SUBJECT: ST. LUCIE UNIT 2 - ISSUANCE OF AMENDMENT RE: PRESSURE/TEMPERATURE
LIMITS AND LOW TEMPERATURE OVERPRESSURE PROTECTION (TAC NO. 76016)

ATTACHMENT TO LICENSE AMENDMENT NO. 46
TO FACILITY OPERATING LICENSE NO. NPF-16
DOCKET NO. 50-389

ST. LUCIE PLANT, UNIT NO. 2

**FIGURE 3.4-2
ST. LUCIE-2 P/T LIMITS, 15 EFPY
HEATUP AND CORE CRITICAL**

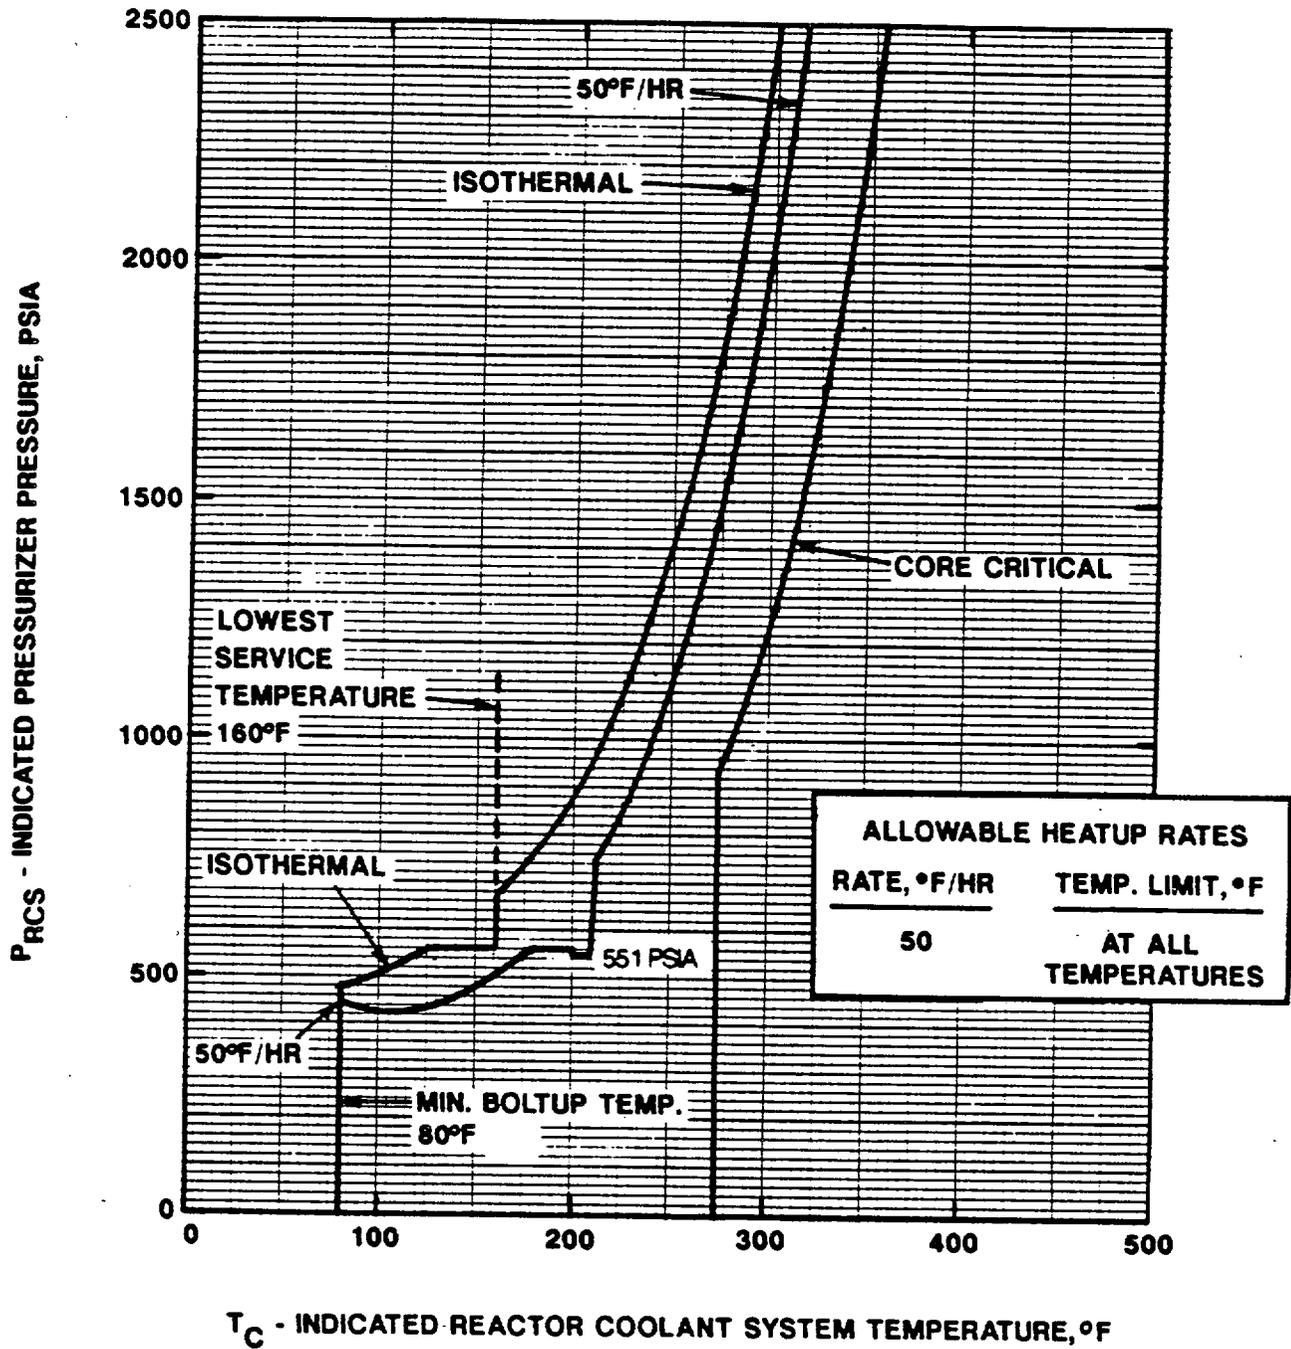
The RCS P/T limits during plant heatup and cooldown are specified in TS Figures 3.4-2 and 3.4-3 for St. Lucie Unit 2. The P/T curves in the current TS are based on an assumed design basis neutron fluence through 6 EFPY.

By letter dated February 7, 1990, as supplemented June 19, 1990, the licensee provided its updated P/T curves in proposed TS Figures 3.4-2 (for heatup and core critical) and 3.4-3 (for cooldown and inservice testing), revised cooldown rates as a function of indicated reactor coolant temperature in proposed Figure 3.4-4, changes in the values of the RCS cold leg temperature at which LTOP should be enabled, and the justification for the changes. The new P/T curves are based on the irradiation damage prediction methods of RG 1.99, "Radiation Embrittlement of Reactor Vessel Materials," Revision 2, U.S. Nuclear Regulatory Commission, May 1988, and are applicable for a period up to 15 EFPY.

The licensee-proposed changes in TS 3.4.9.3, Tables 3.4-3 and 3.4-4, and the associated Bases sections reflect the above discussed LTOP alignment temperatures and the heatup and cooldown rates identified by the updated Figures 3.4-2, 3.4-3, and 3.4-4 in TS 3.4.9.1. The staff finds that they are based on applicable regulatory guidance in Standard Review Plan (SRP) 5.2.2, Revision 2, are reasonably conservative, and are acceptable.
